# Access Compliance Report

## Public Rights-of-Way

| Intersection ID: 10144 | Main Street: FONTANA_AV | Cross Street: VOGEL_CT  | Location: SE           |
| ADA ID: 4153997D2C8F   | Ramp Type: Perp         | Initial Pass/Fail: Fail | Overall Compliance: No |

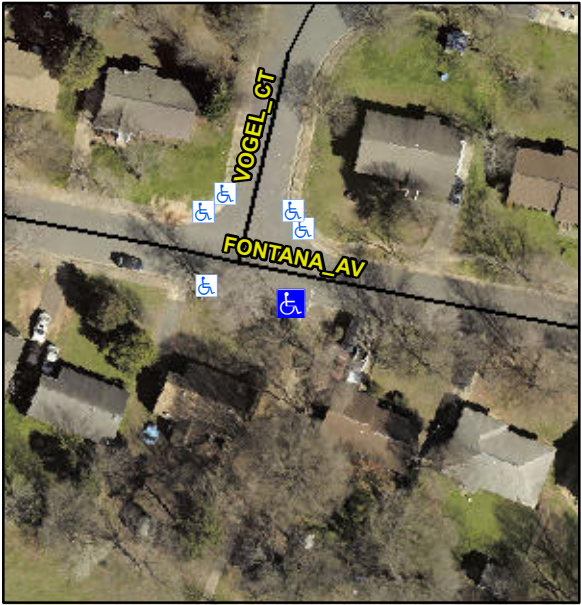
| Codes/Mitigation Info/Possible Solution  |                               |  | Field Measurements/Component Compliance |                             |             |
|--|-------------------------------|--|---|-----------------------------|-------------|
| <p>Surveyor Notes:</p> <p>N/A</p> <p>PROW/ADA:</p> <p>Not Found, R304.2.2</p>    |                               |  | N/A                                     | Flare Type RT               | N/A         |

| Codes/Mitigation Info/Possible Solution  |                               |  | Field Measurements/Component Compliance |                             |             |
|--|-------------------------------|--|---|-----------------------------|-------------|
|  | Remove & Replace Entire Ramp. |  | N/A                                     | Ramp Length (in)            | 61.0        |
